KINGSTON STEAM PLANT - ANNUAL ASH DISPOSAL AREA INSPECTION

KINGSTON STEAM PLANT - ANNUAL ASH DISPOSAL AREA INSPECTION

[illegible] ASH DISPOSAL AREA INSPECTION

PROJECT: KINGSTON STEAM PLANT

SECTION THROUGH NORTH DIKE AND STORAGE AREA
NTS

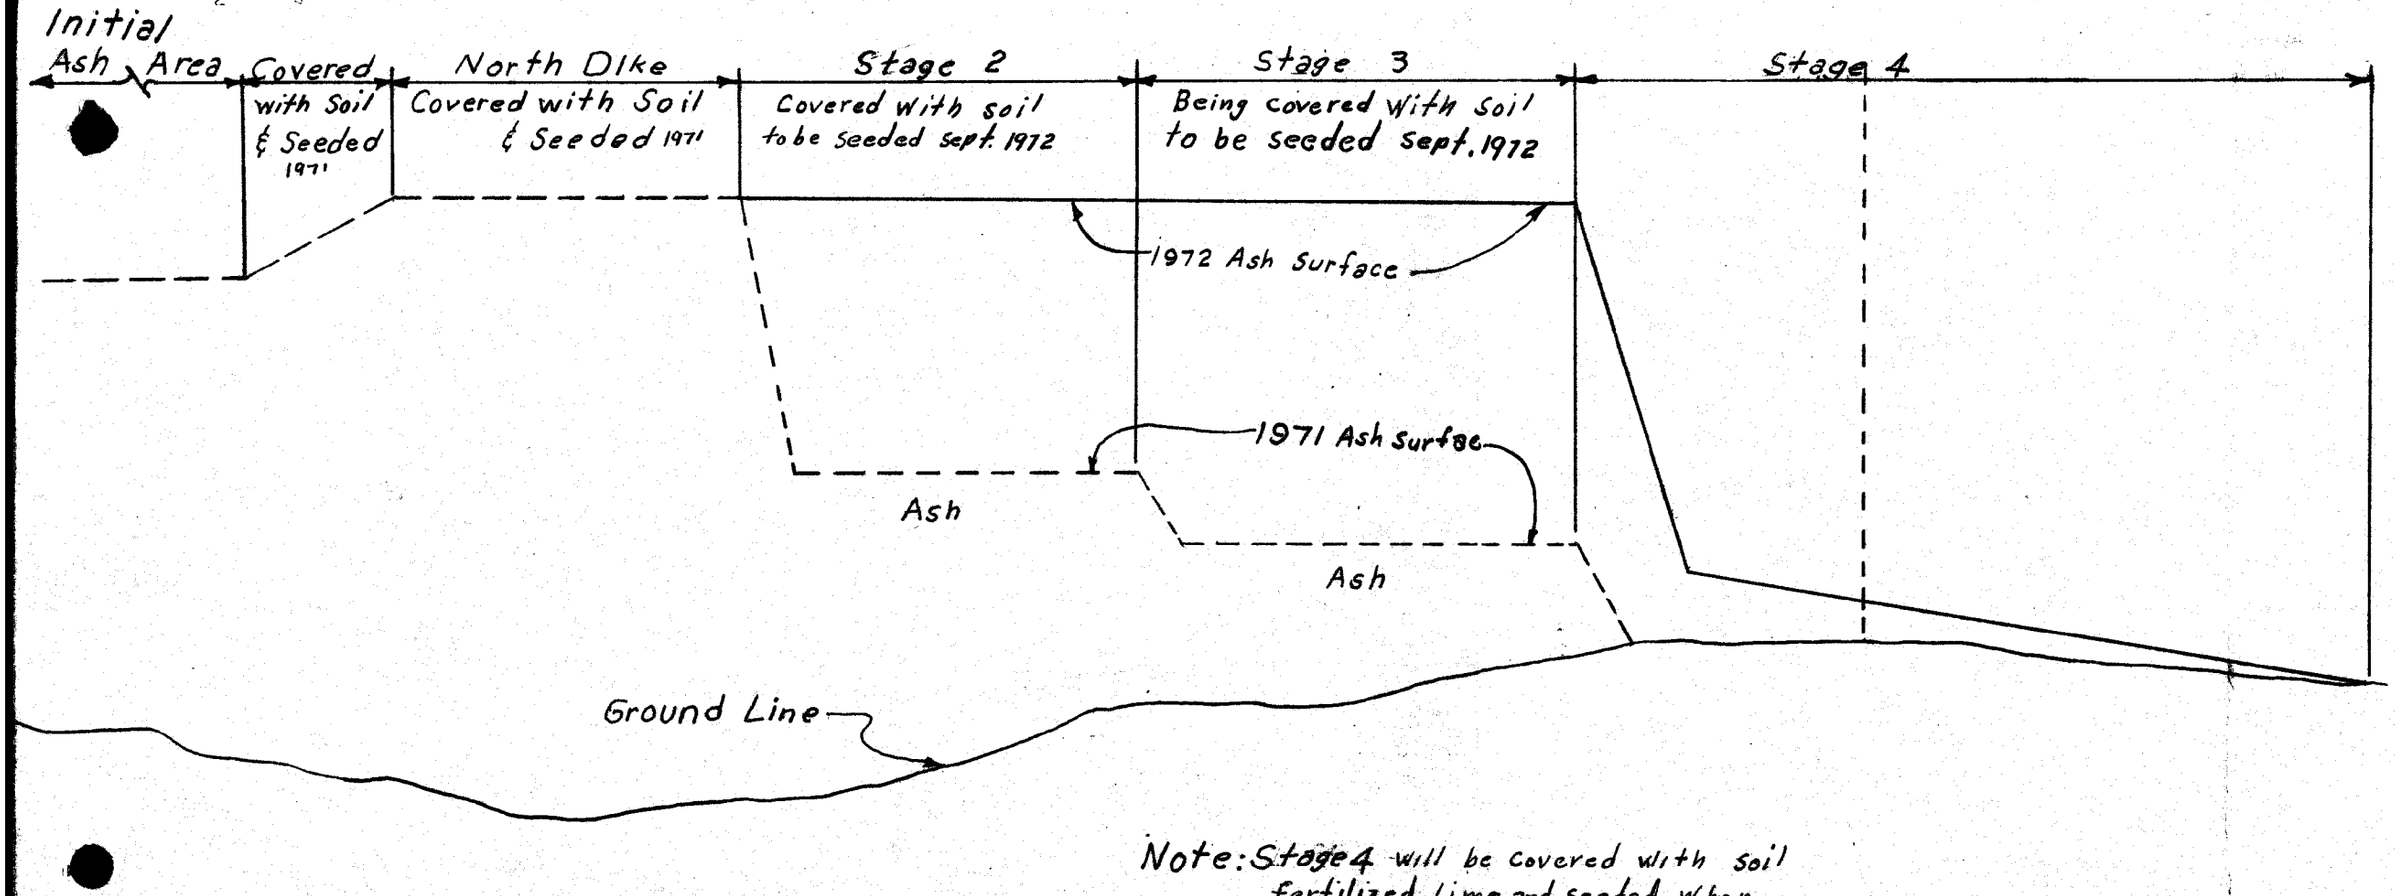
Ash is sluiced into the initial area, then dry hauled to the area adjacent to the north dike where it is deposited in stages (see attached sketch). As each stage reaches the elevation of the top of the north dike, it is covered with earth and seeded. Each stage is approximately the same length as the north dike.

Note: Stage 4 will be covered with soil fertilized, Lime and seeded when final Elevation is Reached.

ASH DISPOSAL AREA

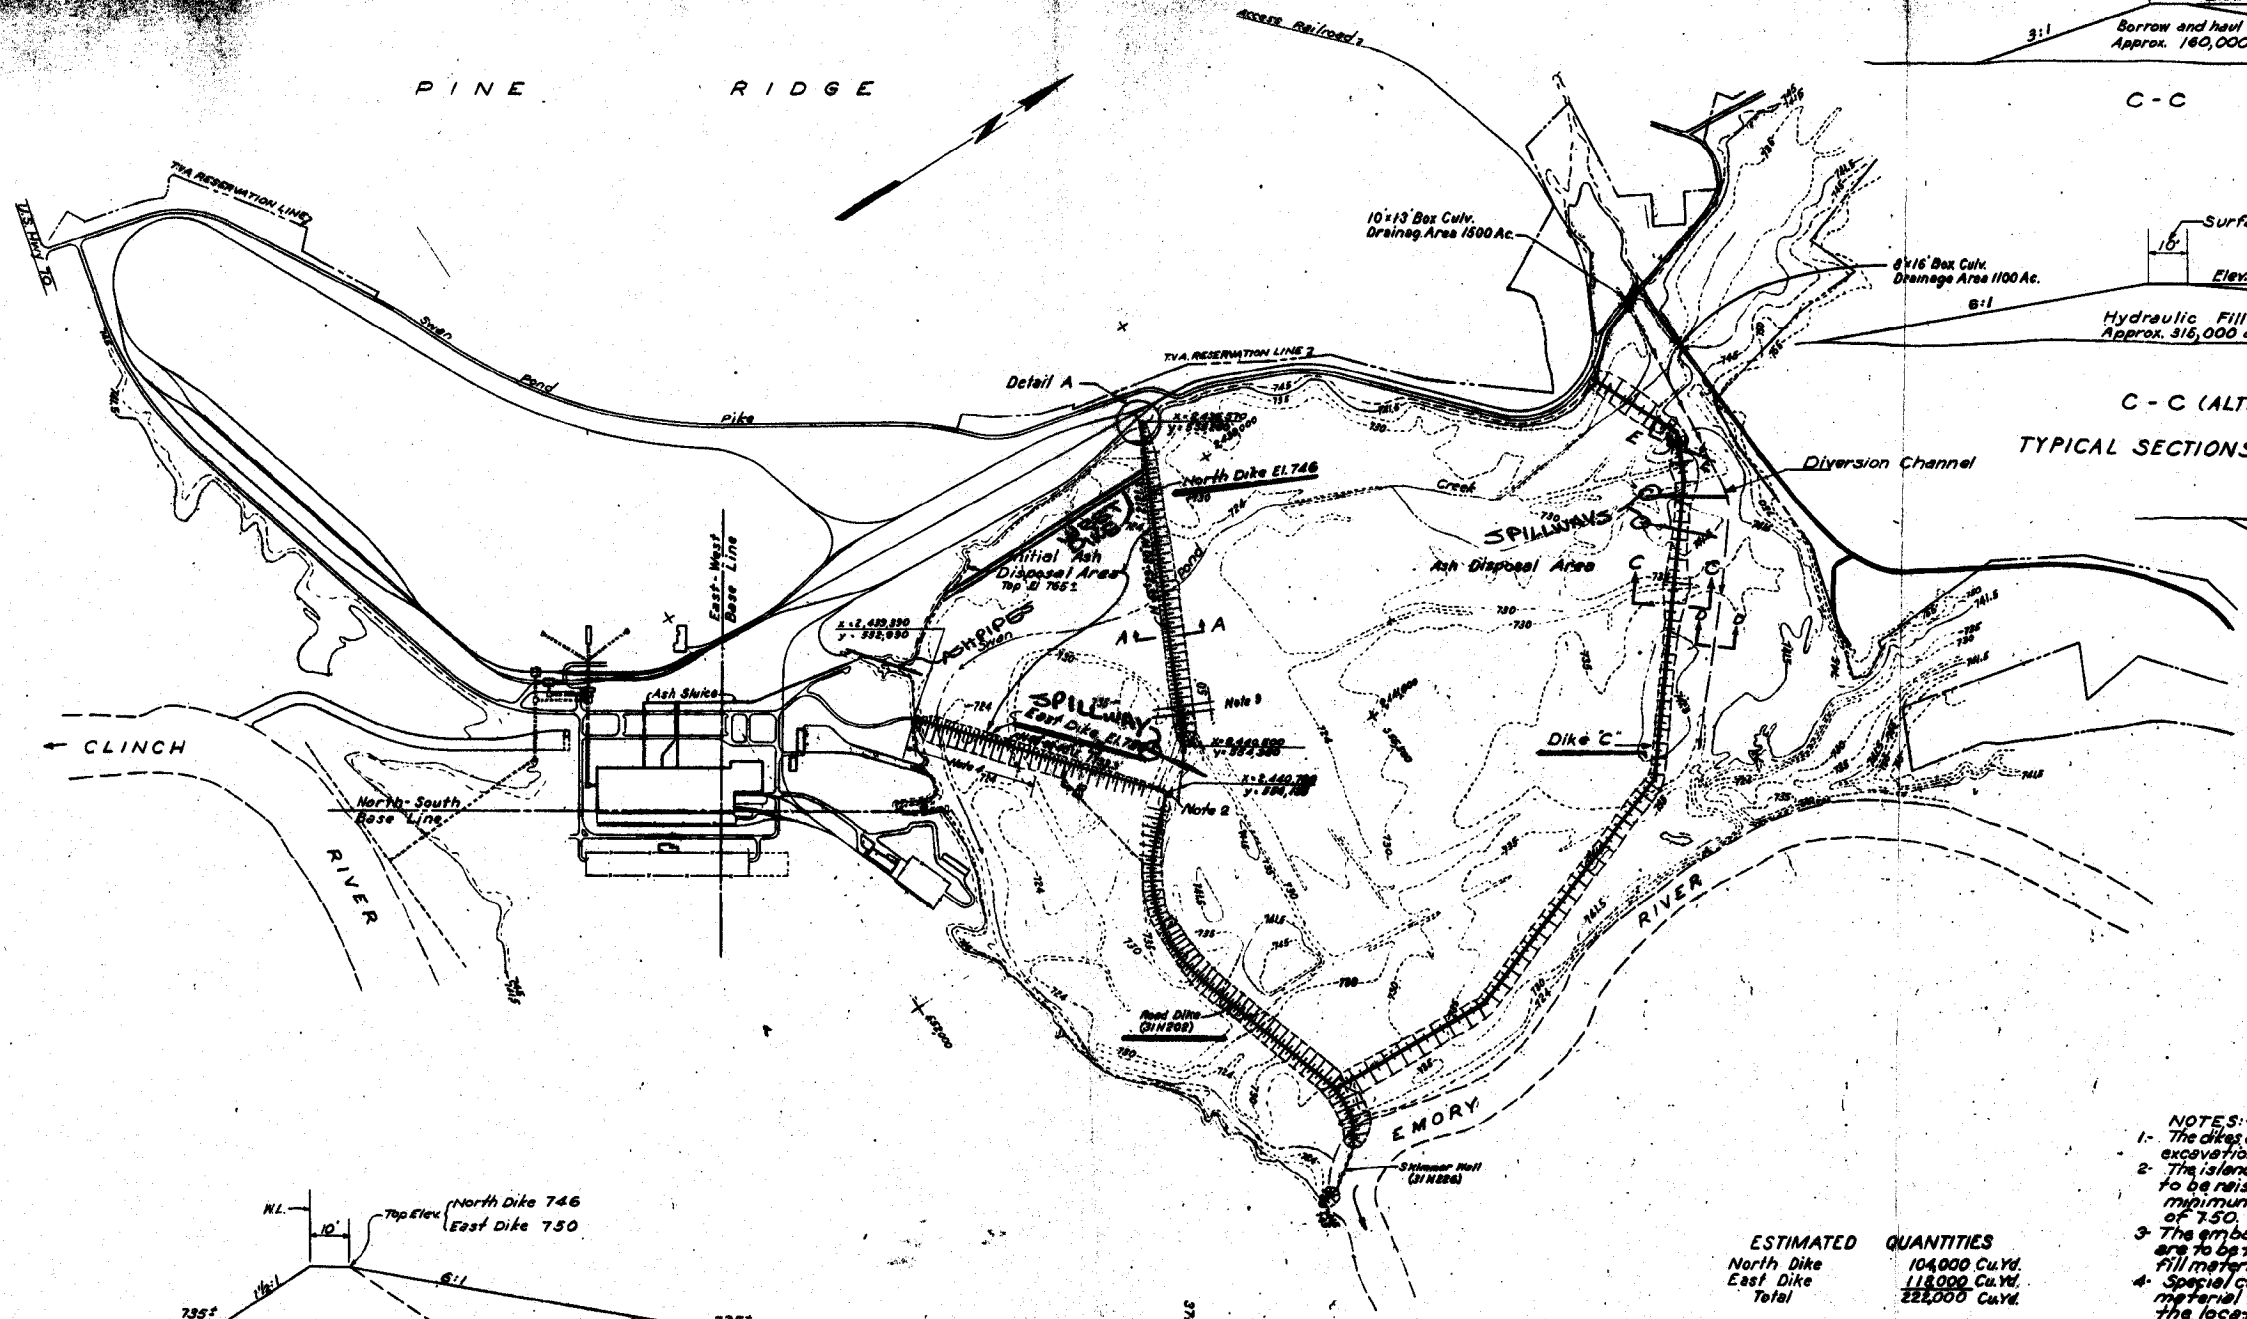
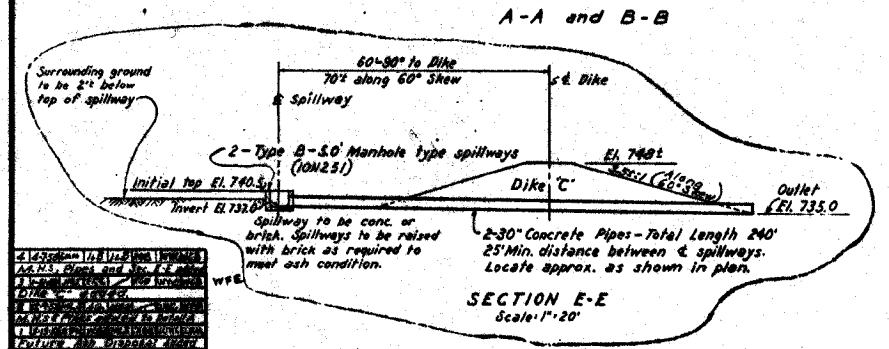
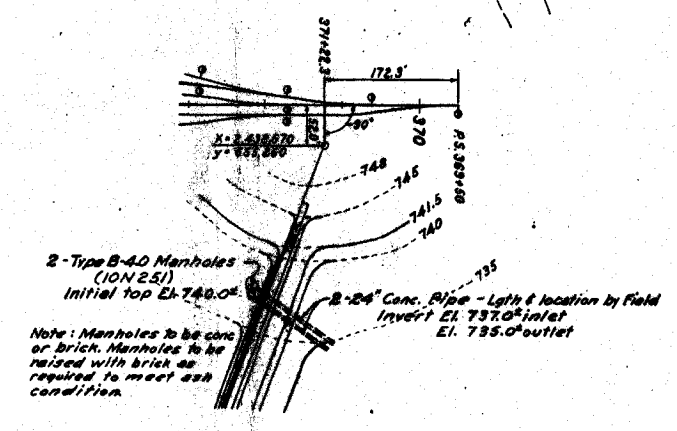
Plant personnel have completed widening and raising dike C by placing earth on the inside and top of the original dike to provide required freeboard and a base for future raising.

Dike C has been widened and raised.
